From: McConnell, DAVE P <dave.p.mcconnell@lmco.com>
Sent: Tuesday, September 27, 2016 9:53 AM
To: Liming Qi; Michael Macgowan; Mike Goodman
Cc: Manuel Padurean; Partnumber Management Norway; Grant Robinson
Subject: RE: Clevis spring rod support bracket HS-HTN PN 76400-23514-047

Customer: Thai Aviation Services Limited
Aircraft Serial Number: 760731
Aircraft Model: S-76C++
ATA: 67
Part Number: 76400-23514-047
Case Number: C0041109
Title: Balance Spring Bracket Assembly Hole Elongated

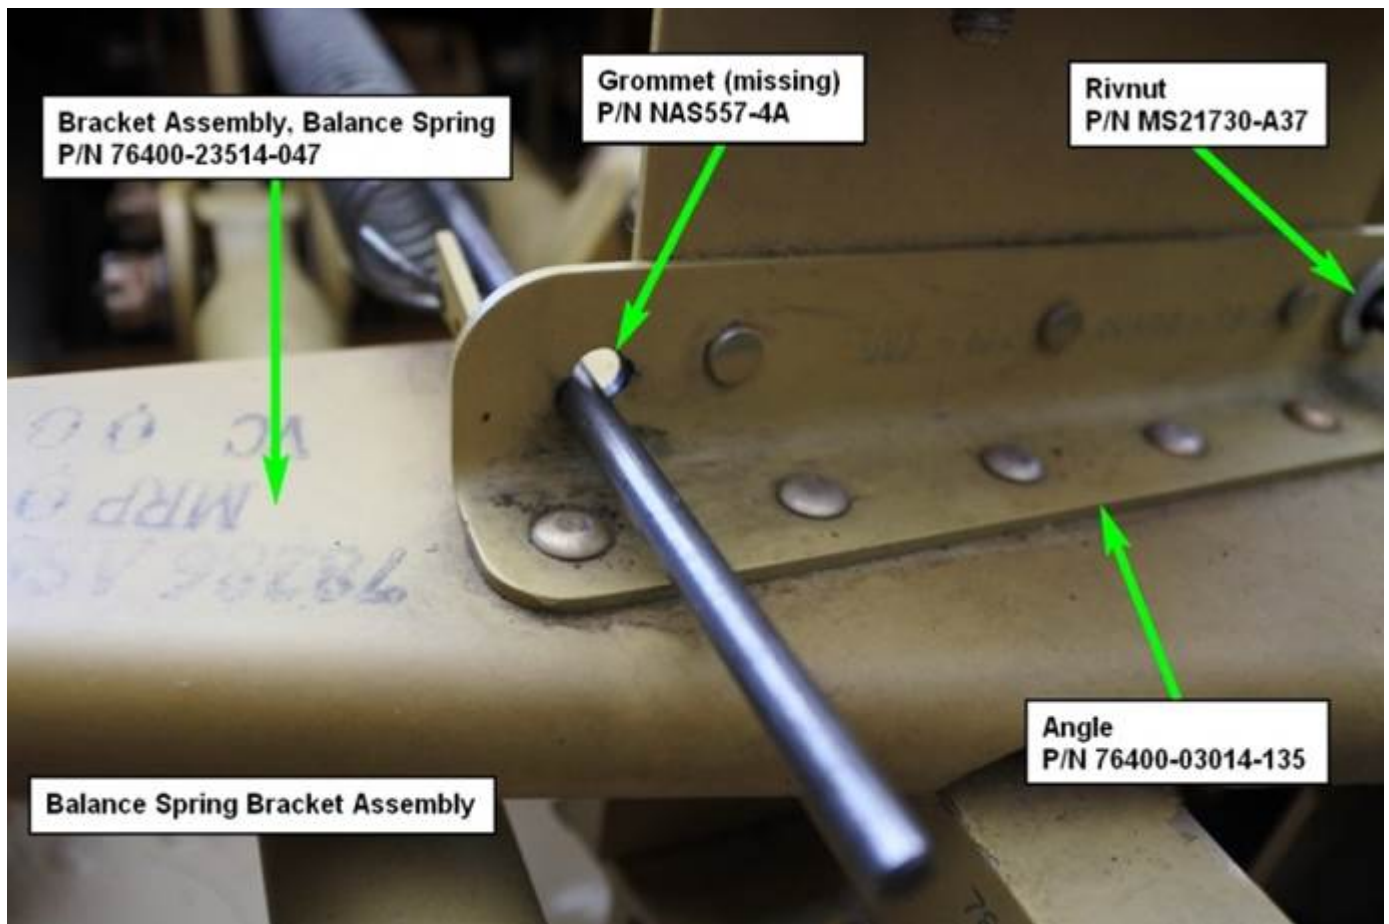
The -047 differs from the -043 in that it has one P/N MS27130-A37 rivnut mounted in the P/N 76400-03014-135 bracket to support the pitch spring rod.

The collective spring rod hole does not use a rivnut. Instead it has one P/N NAS557-4A grommet fitted. Yours is missing.

The wear in the collective spring hole appears to be too great to simply reinstall a new grommet.

Sikorsky will recommend that you order a replacement P/N 76400-23514-047 Balance Spring Bracket Assembly. In the meantime you can continue to operate as long as the collective spring rod isn't in danger of getting stuck in the keyhole slot or contacting the -135 angle. You can clean up the keyhole slot if need be to enable the rod to travel more smoothly.
